Gulfstream American

SERVICE BULLETIN NO. 163
"FAA (DER) APPROVED"

SUBJECT: AILERON TORQUE TUBE INSPECTION AND MODIFICATION

FIGURE 1

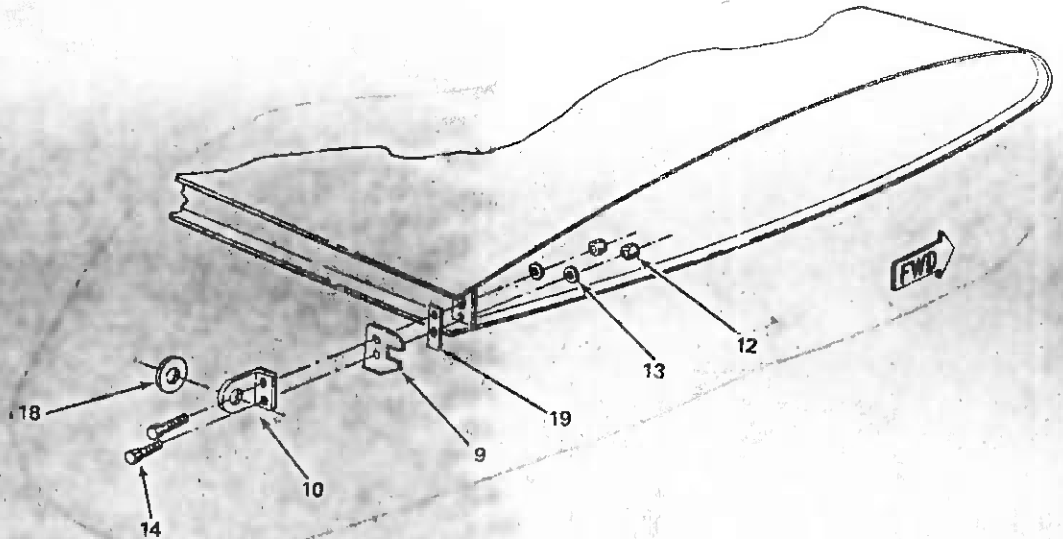
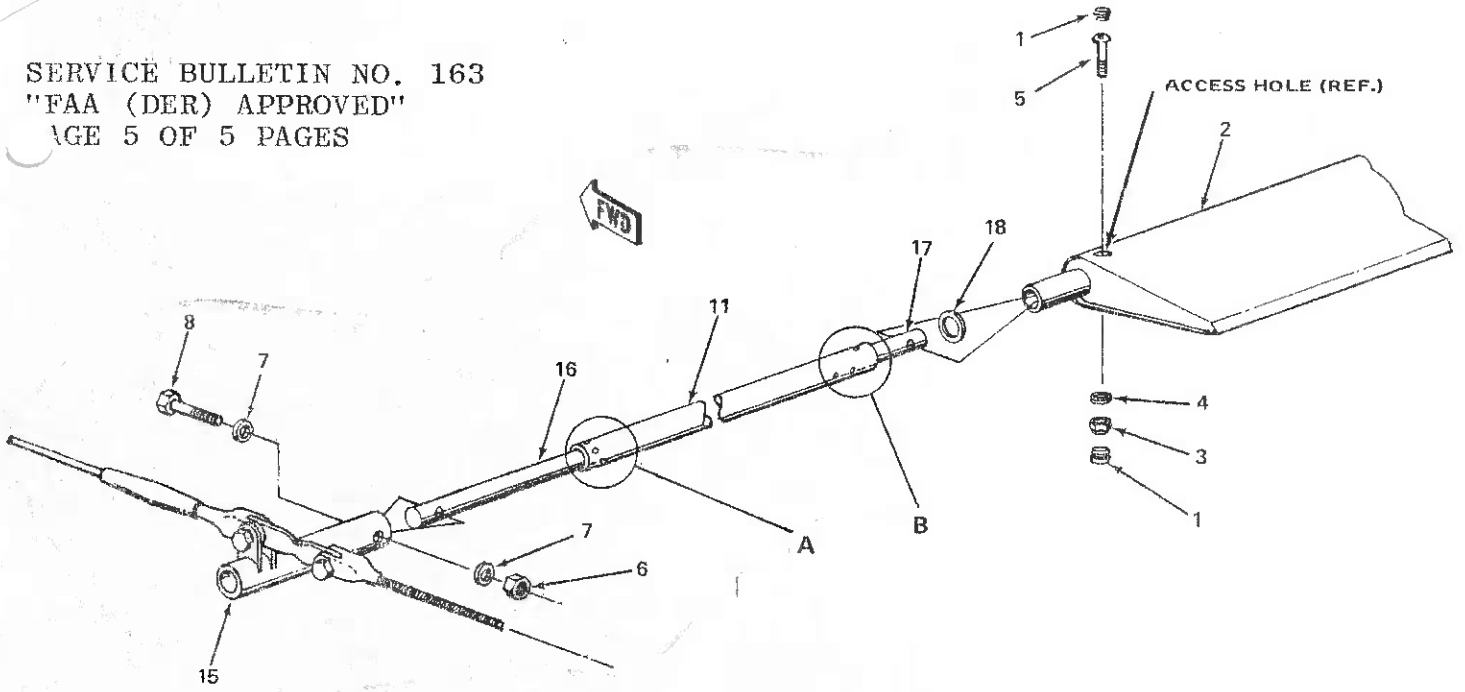
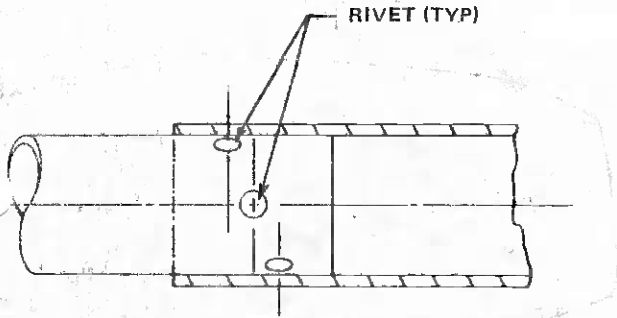
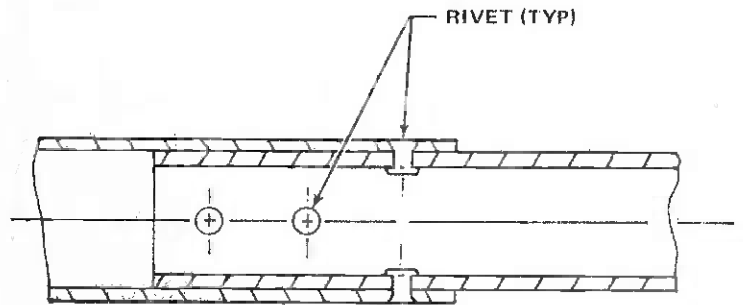
The aileron torque tube assembly, Part No. 5202035-505, contains two joints that require inspection (REFER TO FIGURE 1). The torque tube assembly extends inboard from the aileron and may be separated from the aileron by removing attach hardware through access holes in the aileron skin at the inboard end. Ailerons on affected aircraft requiring inspection may be identified by visually inspecting for these access holes. On aircraft on which ailerons do not have these access holes, the aileron torque tube is an integral part of the aileron and thus is not affected by this Service Bulletin.

Referring to Figure 1, the aileron torque tube assembly requiring inspection consists of a tube, Part No. 5202035-11 (11), an inboard sleeve, Part No. 5202035-6 (16), and an outboard sleeve, Part No. 5202035-11 (17). These sleeves (16 and 17) are to be assembled to the tube (11) with bonding agent or rivets and bonding agent. This Service Bulletin is intended to provide the necessary instructions for inspection of the assembly joints to verify that assembly was completed with bonding agent or rivets and bonding agent. If, however, assembly was with rivets only, modification must be accomplished in accordance with the instructions provided in Service Kit SK-144.

- (1) Visually inspect both inboard and outboard torque tube joints for assembly with bonding agent or rivets and bonding agent. When inspecting to see if a joint is bonded, it may be possible to see bonding agent around the circumference of the joint, where the tube and sleeve mate. If joint is not bonded, proceed with modification in accordance with Service Kit SK-144.
- (2) If unable to visually determine if joint was assembled with rivets and bonding agent, rivets must be removed as per instructions in Service Kit SK-144.

With rivets removed, attempt to separate tube from sleeve by hand twisting.

- (a) If unable to separate, reinstall rivets (Part No. CR3242-5-4 supplied in Service Kit SK-144) as per instructions in Service Kit SK-144.
- (b) If able to separate, joint must be modified in accordance with instruction in Service Kit SK-144.
